Re: Addison Circle Phase I
AB Project Number EABPRJ98003968
Public Infrastructure Phase I

TEXAS DEPARTMENT OF LICENSING AND REGULATION
ARCHITECTURAL BARRIERS - INSPECTION RESPONSE

**RE: Ramp Modifications – Addison Circle Phase I
HZI Project No. 01-3363-02**

BARRIER FREE RAMP DETAIL

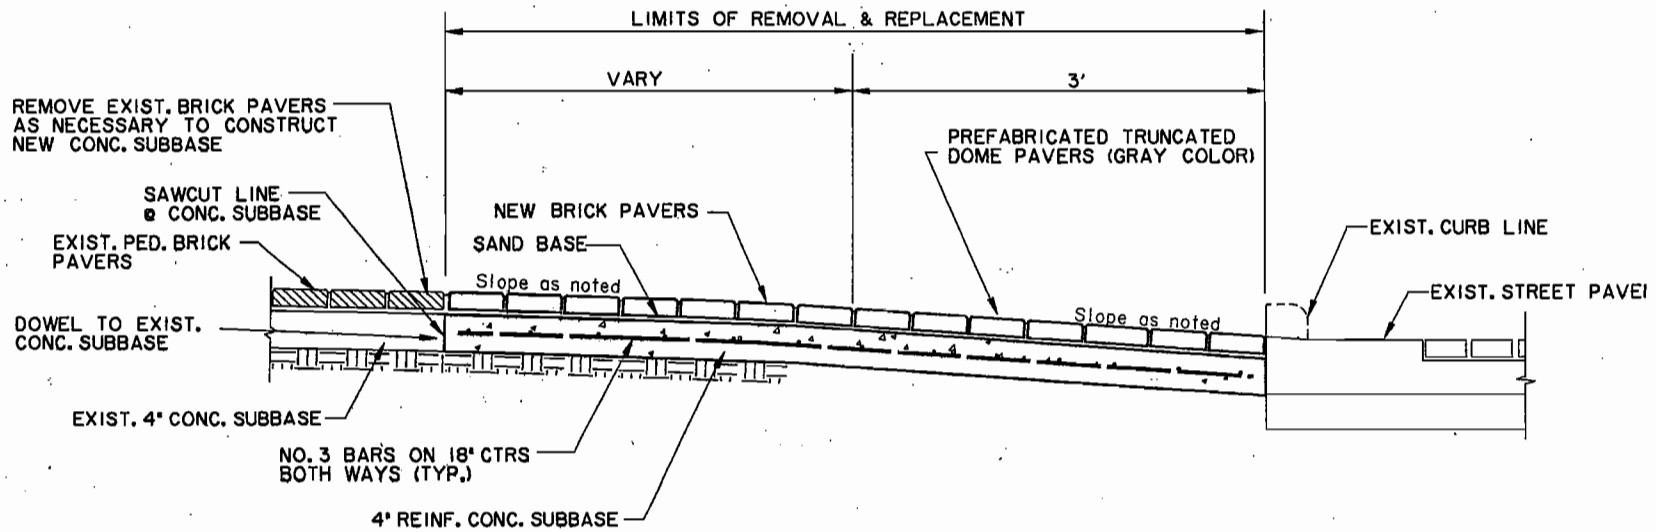
1. What are the cross-slopes in ramp and “triangle transitions”?
Cross-slopes in ramps and transitions indicated on plan.
2. Do sawcuts go thru curb? Is there any curb removal anticipated?
Plan revised to show sawcut of curb. Limits of curb removal and replacement shown.

3. Is four feet enough to meet required grade for ramp at 4995 Addison Circle?
Ramp at 4995 Addison Circle revised to meet required grade slope. All ramps revised to meet ~~minimum~~ ^{max} slope of 8% .

4. Do we need to dowel into existing subbase? Show dowel detail.
Doweling into existing subbase is recommended. Detail for doweling added to detail sheet.

5. What about replacement (concrete detector strip removal) ?
Concrete detector strip is being replaced by prefabricated truncated dome pavers on 4 inch concrete subbase.

6. How do we address cutting and replacement of partial bricks.
Brick paver removal will extend to 1 foot beyond the limits of subbase sawcut. There will not be cutting of brick pavers as noted on detail Section A-A.
